SUBJECT: Accept the Low Bid and Award the Contract for the Construction of Grand Avenue Resurfacing and Widening Project, Community of Lakeland Village. 1st District; [\$4,523,019]; Local Funds 100%

Project Number: C4-0074

MODIFICATIONS / CLARIFICATIONS TO PLANS

DESIGNED BY APPROVED BY: 	LAYOUT GRAND AVE RESURFACING & WIDENING	SHEET No. L-5
	DATE: 1-29-15 MICHAEL O. MUETING PROJECT MANAGER COUNTY OF RIVERSIDE	STA 128+00 TO 158+00	SHEET 8 OF 24

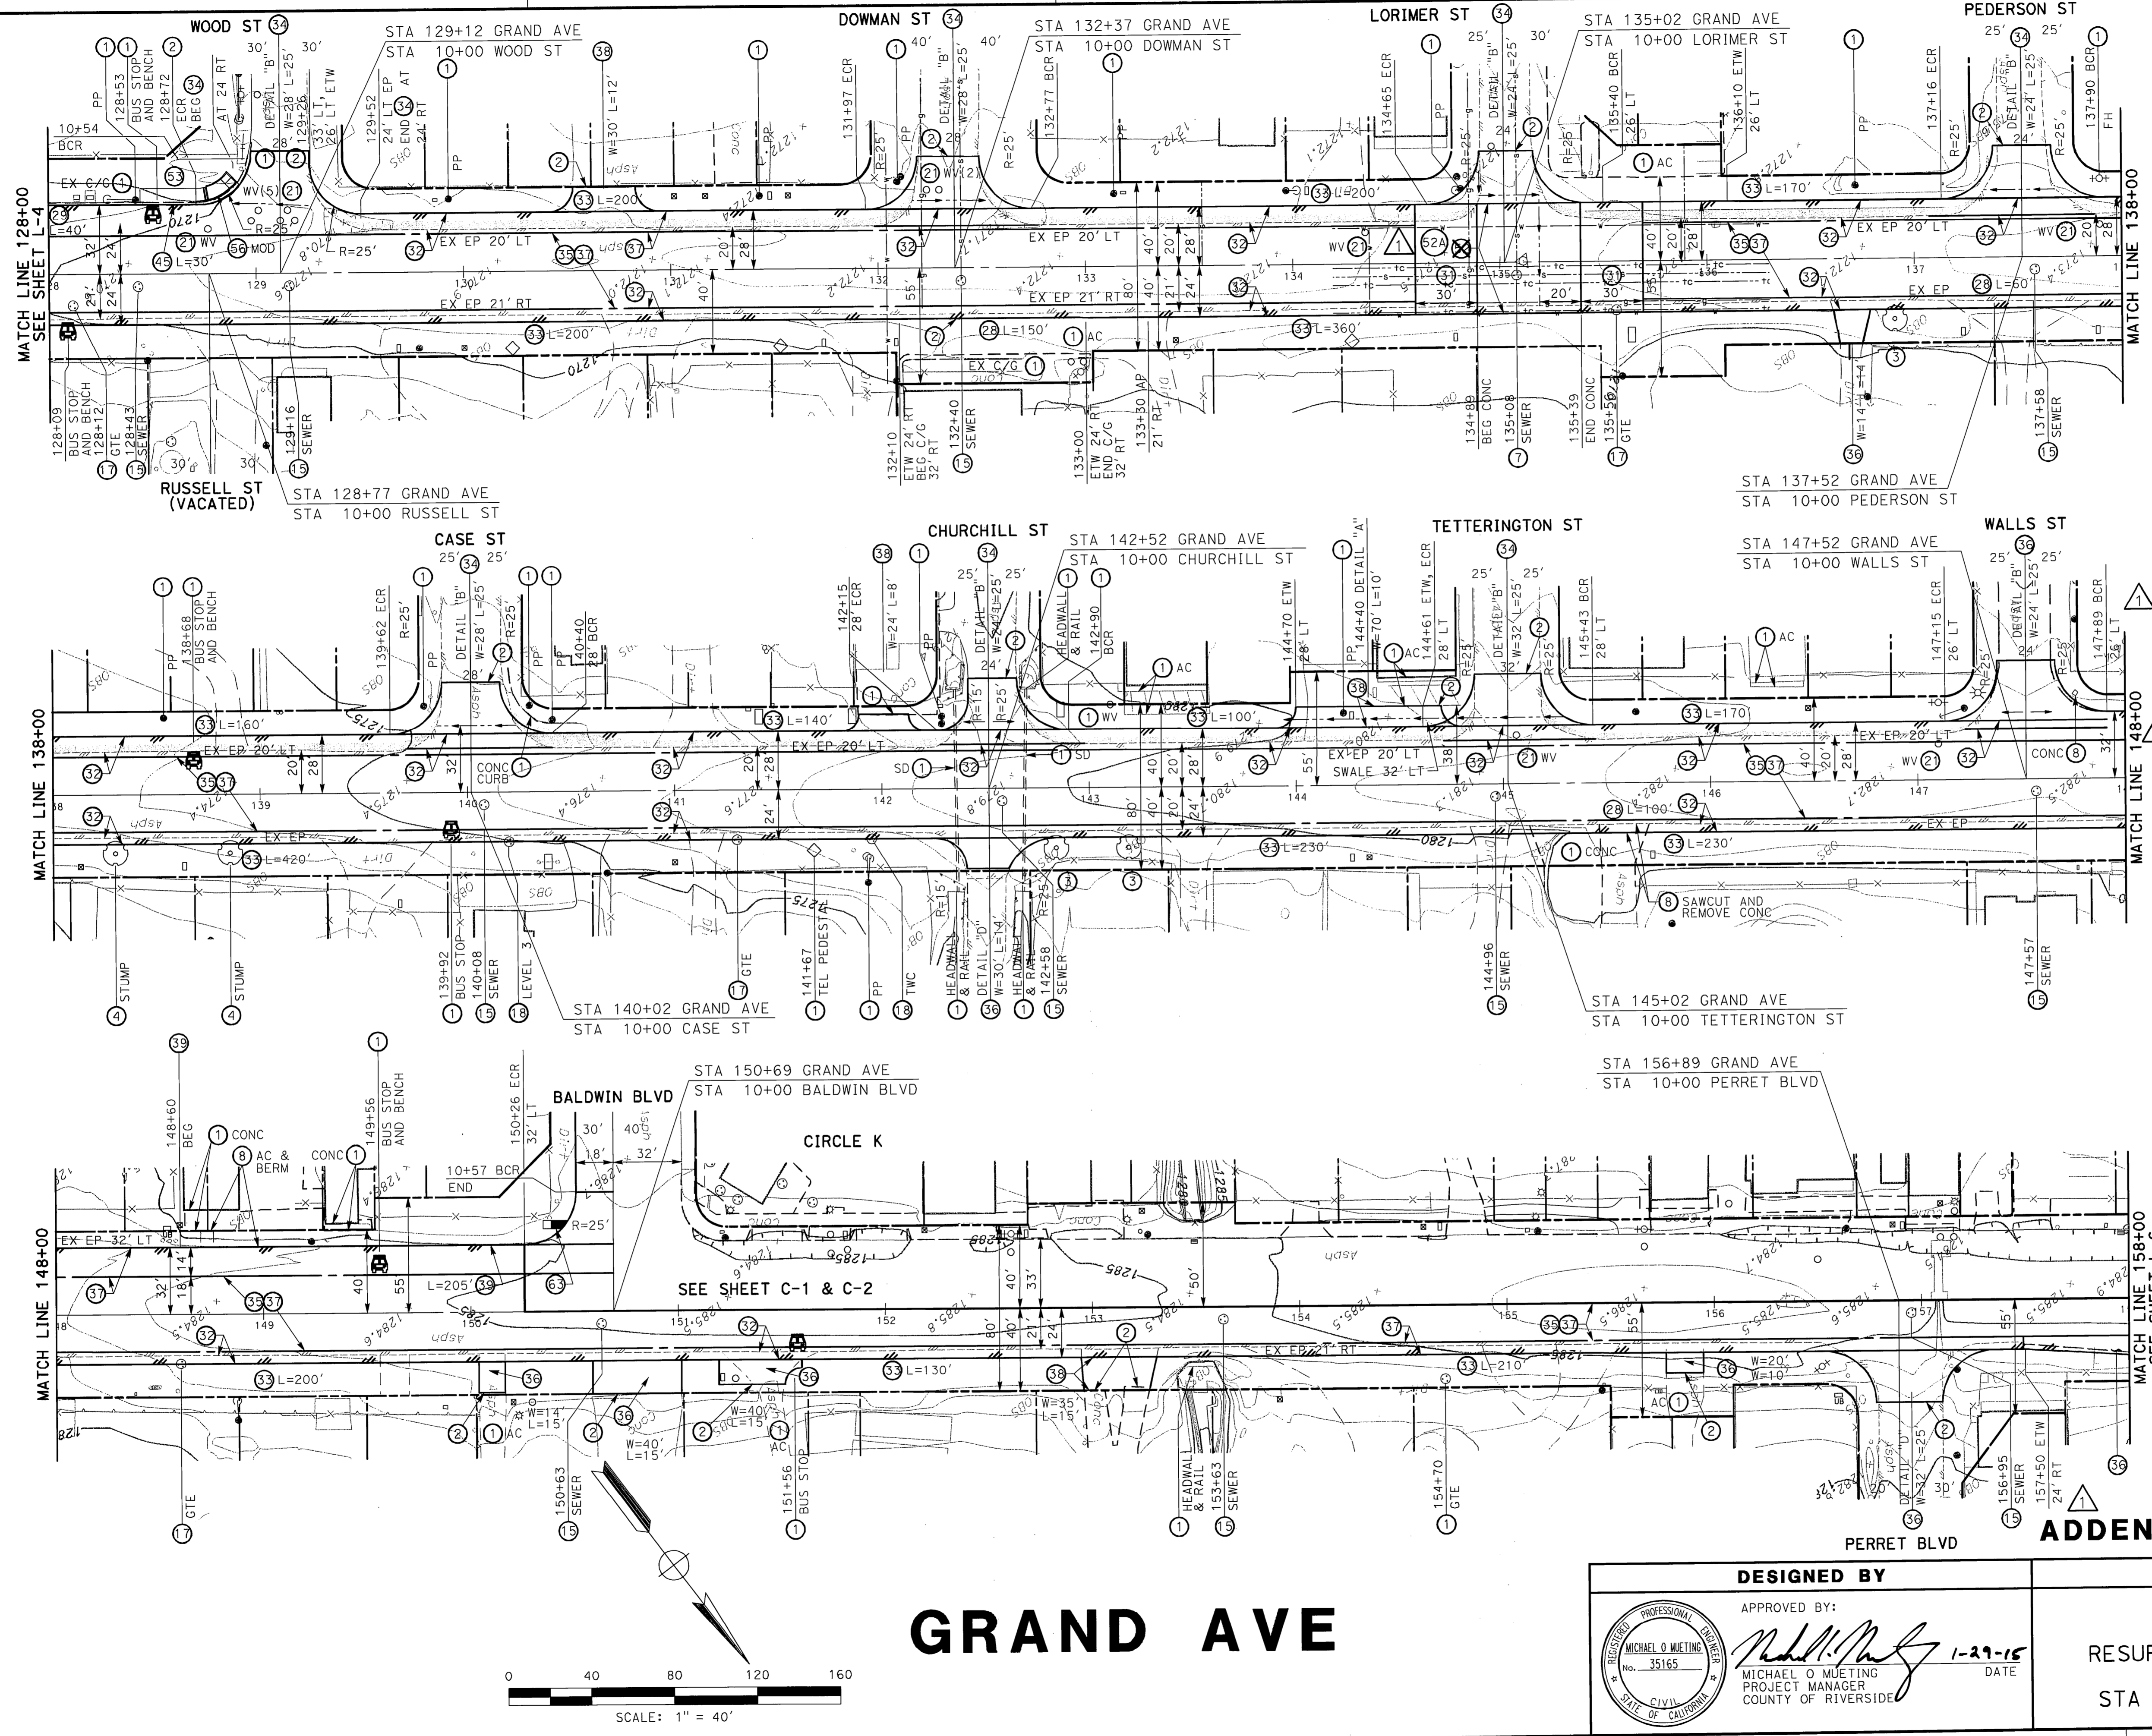
Item 13: Construction Note (Sheet L-5)

Refer to plan sheet L-5, delete construction note 52 and replace with 52A
"CONSTRUCT DIP SECTION PER STD NO. 307, MODIFIED 10" THICK RAPID STRENGTH
CONCRETE WITH #5 BARS AT 12" O.C. LENGTH AND WIDTH AS SHOWN.

1. **Plan Sheet L-5 (8 of 24)**

- 24 CONSTRUCT DIP SECTION PER STD No. 307, MODIFIED WITH RAPID STRENGTH CONCRETE AND No. 5 BARS AT 12" O.C. LENGTH AND WIDTH AS SHOWN

▲ REVISED WITH ADDENDUM No. 2 01-29-15
ADDED SEWER LATERAL APPROX LOCATIONS
